# Evaluation Report 310

## International Harvester 596 Tandem Disk Harrow

# INTERNATIONAL HARVESTER 596 TANDEM DISK HARROW

**FIGURE 10.** Weld Failure on Wing Wheel Support.

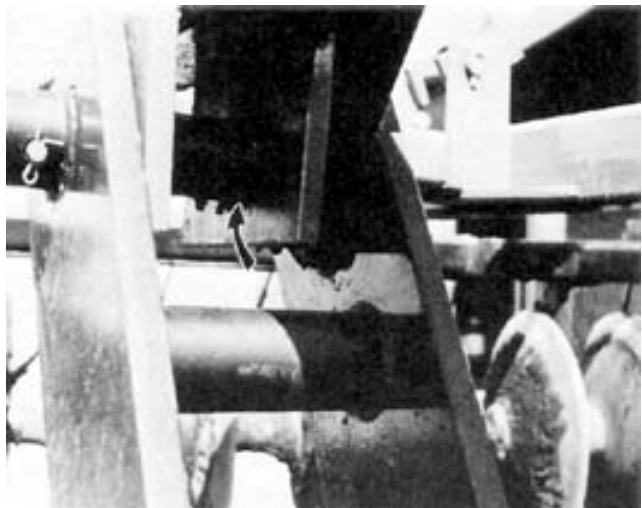
**Weld Quality:** Weld quality was poor in several places on the test machine. This resulted in a weld failure on the right wing wheel support (FIGURE 10). It is recommended that the manufacturer improve weld quality.

8. No other similar failures have been experienced, however, manufacturing has been advised of the reported weld failure.
9. We feel the routing is adequate as it was done in cooperation with the hose manufacturer.
